300 Gray's Inn Road

Planning Design Addendum
September 2023

Planning Design Addendum
Summary

Acton Street Elevation
Design Changes

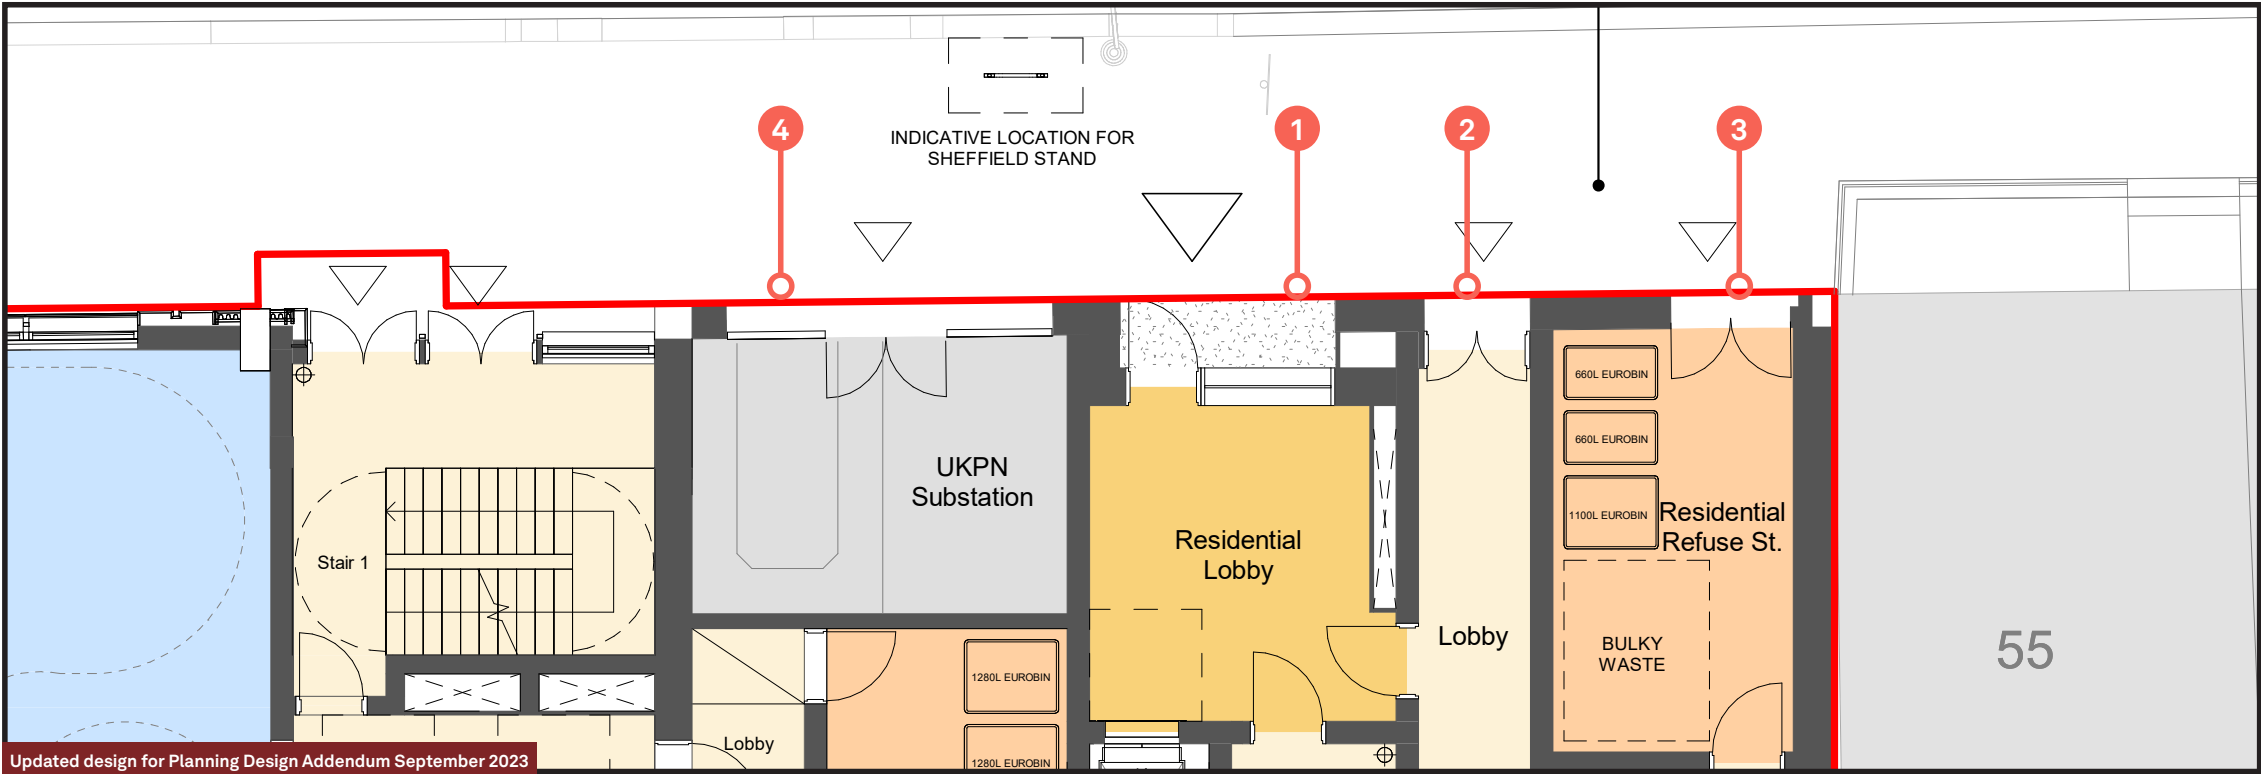
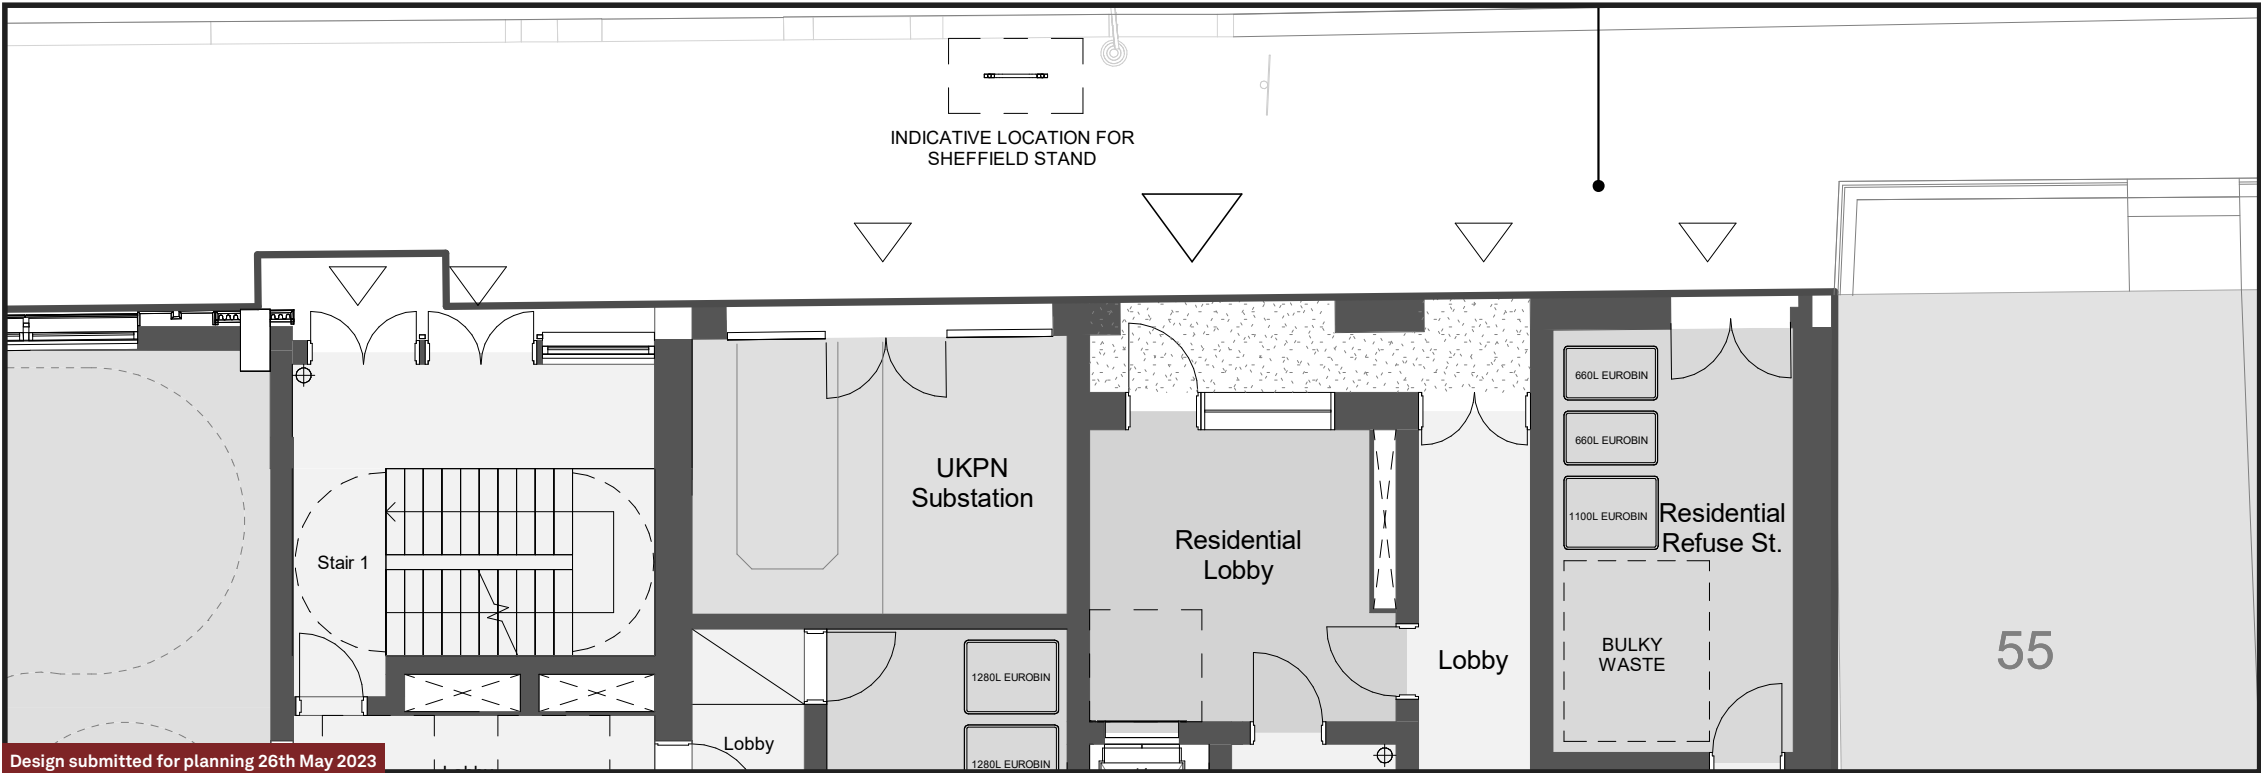
Comments were received in relation to the depth of the recessed entrance to both the residential homes and the bike and bin store. The preference is for no recess entrance, however due to the limitations of the door swing impact on the pavement, and the need for a protected door way, a recess is still required.

The following changes have been made to reflect comments received:

- 1
- The recessed entrance has been reduced in depth by 600mm and the width has been reduced due to the door to the ‘Lobby’ no longer being part of the recess.
The resulting design maintains the 900mm depth for a protected lobby as needed by Building Regulations. It also avoids oversailing on the pavement.
- 2
- The recess to the ‘Lobby’ has been removed, a small indent in plan is retained to align to the external design concept.
- 3
- For clarity the proposed design to the external entrances to the UKPN Substaion and Residential Refuse Store are vertical metal louvres, more detail can be seen in the visual on the next page.
- 4

Acton Street Elevation Design Changes

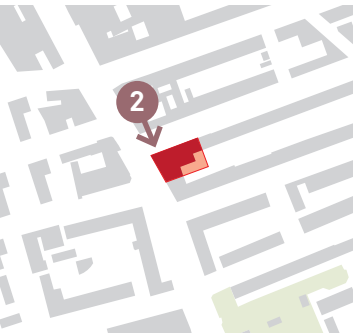
Primary Recess

The main entrance recess is reduced.

Updated to show reduced recess to the residential entrance.

3 Rear Residential Balconies Design Changes

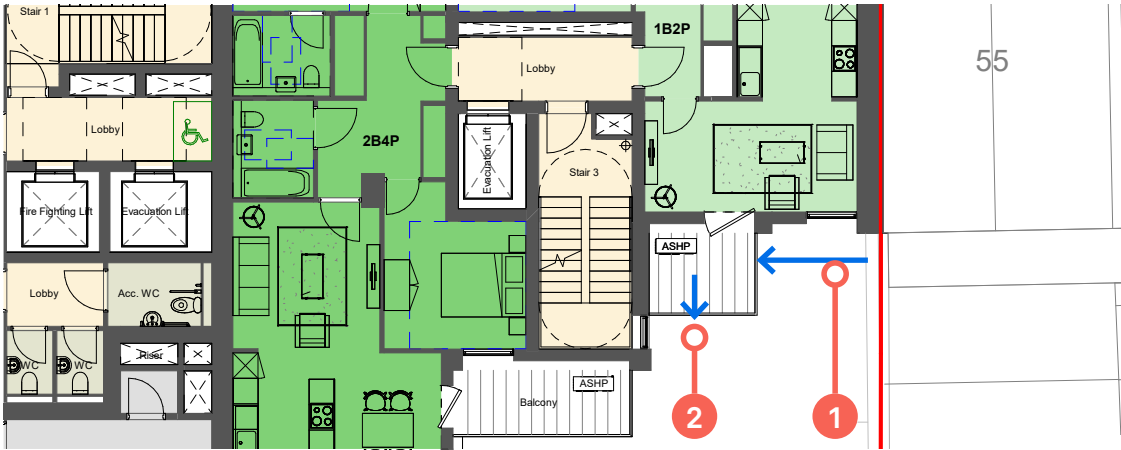
Comments were raised around the eastern rear balconies to the residential component of the design and their relationship to the neighbouring homes.

Although the submitted design adopted measures to mitigate impact of the balconies onto the adjacent property through screening, it was felt that the balconies should be positioned further away from the boundary line with 55 Acton Street.

- 1 The balcony has been pulled back 2.4m from the proposed balcony line adjacent to the boundary line with 55 Acton Street.
- 2 The balcony steps out to ensure minimum space standards are met.
